**MAJOR PROJECT ASSESSMENT:  
Pacific Highway Upgrade -  
Oxley Highway to Kempsey  
(MP07\_0090)**

Director General's  
Environmental Assessment Report  
Section 75I of the  
*Environmental Planning and Assessment Act 1979*

February 2012

Figure 3 – Wildlife Corridors and Key Habitats

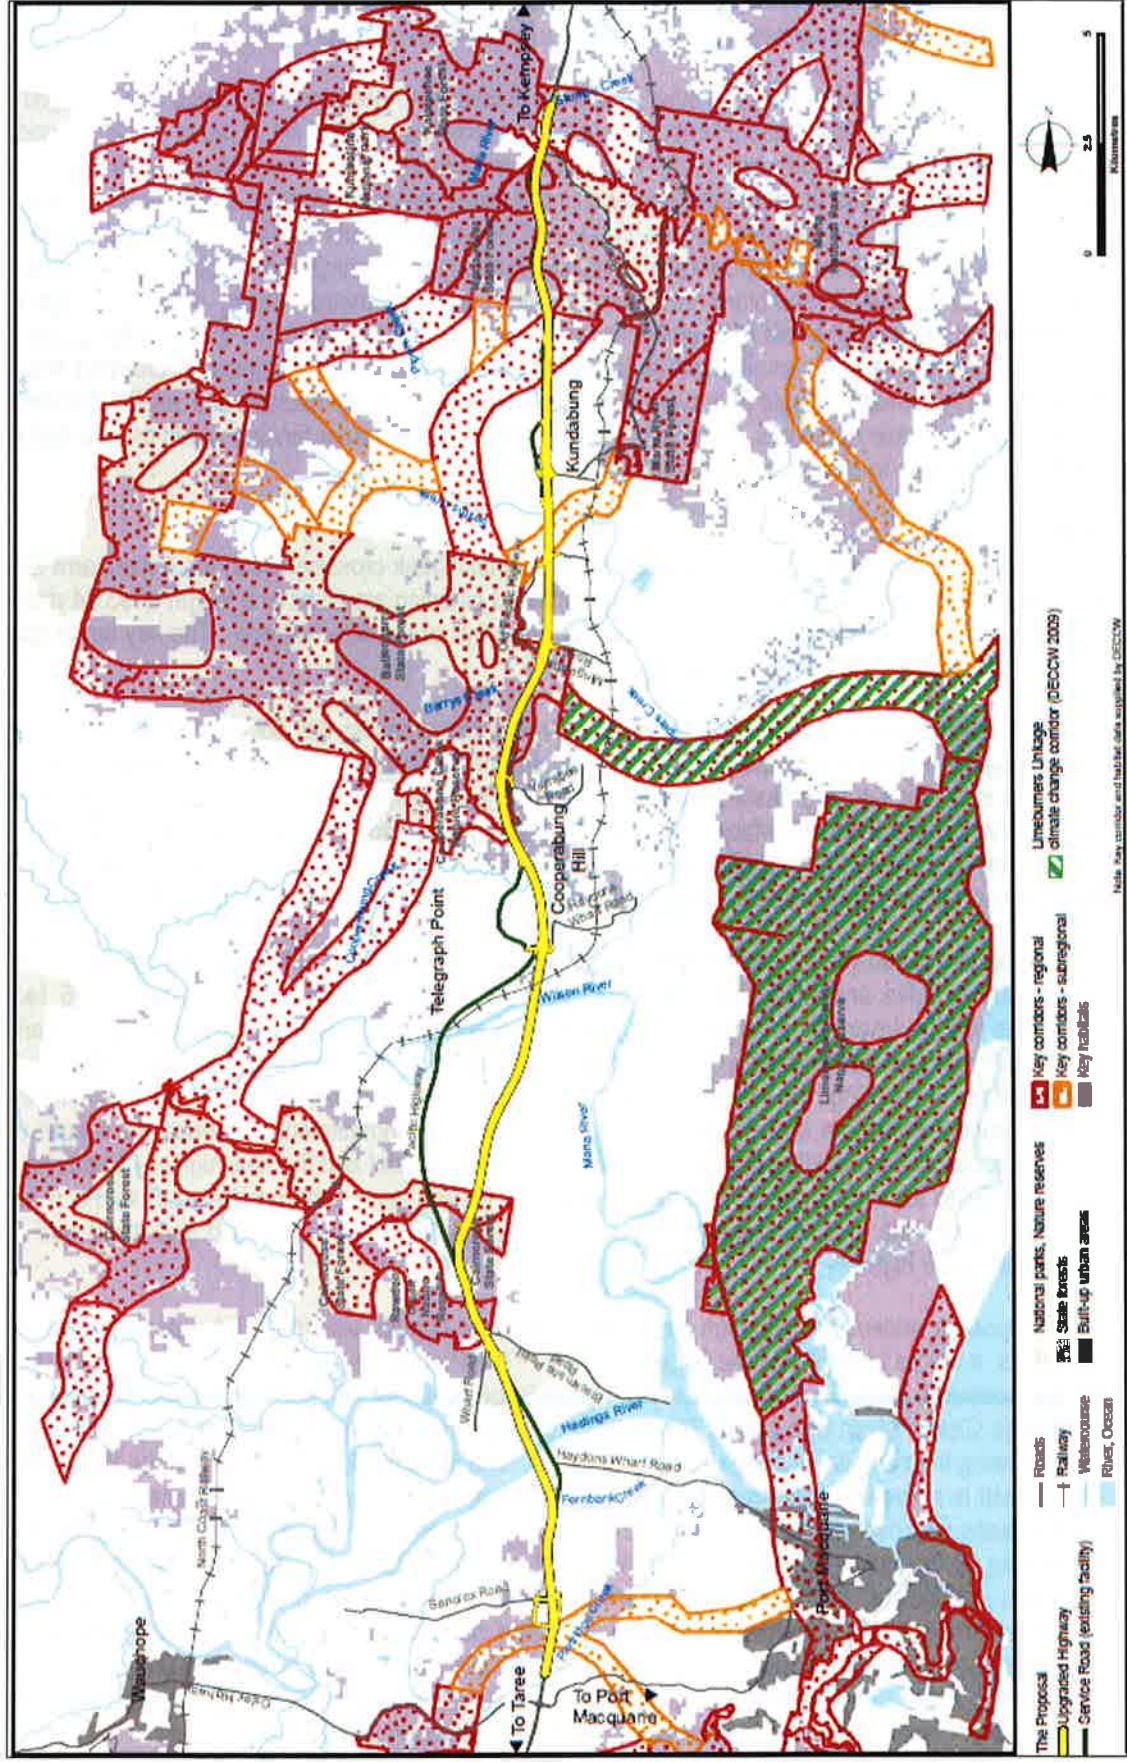
The proposal would remove a long strip of remnant vegetation along the proposed alignment, including the removal of vegetation within key habitat areas associated with regional and subregional corridors (refer to Figure 3). These areas of key habitat are located:

The EPA considered that the proposed fauna crossing structures would provide limited connectivity across the highway as it largely relied on infrequently placed combined structures along the alignment to facilitate fauna movement. It noted that the proposal traverses areas of intact vegetation with a wide variety of habitat types and considered the proposal for 9 dedicated fauna crossings (and several bridge crossings) over the length of the corridor would not cater for all habitat types (and associated range of fauna species). It recommended that combined structures in natural habitat areas and regional corridors should have minimum dimensions of 3.0 metres x 3.0 metres and be spaced at 500 metre intervals. In areas outside of regional corridors combined structures should have minimum dimensions of 2.4 metres x 2.4 metres. The EPA considered the retention of vegetation in the median and on road verges in areas of glider habitat was preferable to the provision of rope bridges and glider poles.

In response to concerns about the adequacy of the proposed fauna crossing measures, the Proponent considered that it had maximised the size of crossings as far as possible within topographical constraints and engineering design requirements. The provision of culverts with minimum dimensions recommended by the EPA would result in a wider footprint, greater area of land impacted, more vegetation clearing, increased property acquisition, potentially greater heritage impacts, higher embankment levels, higher cost and potentially increased traffic noise and amenity impacts from alignment and grade changes that would be necessitated by changes to crossing designs. The Proponent states that of the 26 combined crossings proposed, 15 would have with minimum dimensions of 3.0 metres x 3.0 metres. Thirty eight fauna crossings would be located outside regional corridors of which 22 crossings meet or exceed the minimum dimensions recommended by the EPA. The Proponent indicated that it would further review the size of the crossing structures during detailed design in consultation with the EPA and DPI.

Following the lodgement of the Response to Submissions, the Proponent has undertaken additional investigation into the design of the fauna crossings in consultation with the EPA. As a result of these investigations, the Proponent has further refined the location and design of fauna crossings, particularly in areas of key regional habitat and wildlife corridors and with regard to the design principles recommended by the EPA. The Proponent has added 4 new dedicated fauna crossings in areas of key habitat and key regional/ sub regional corridors:

- Station 1030 in Sancrox Road sub-regional corridor;
- Station 9700 and 11670 – Rawdon Creek Nature Reserve and Cairncross State Forest key habitat and key regional corridor; and
- Station 23140 – Ballengarra State Forest key habitat and key regional corridor.
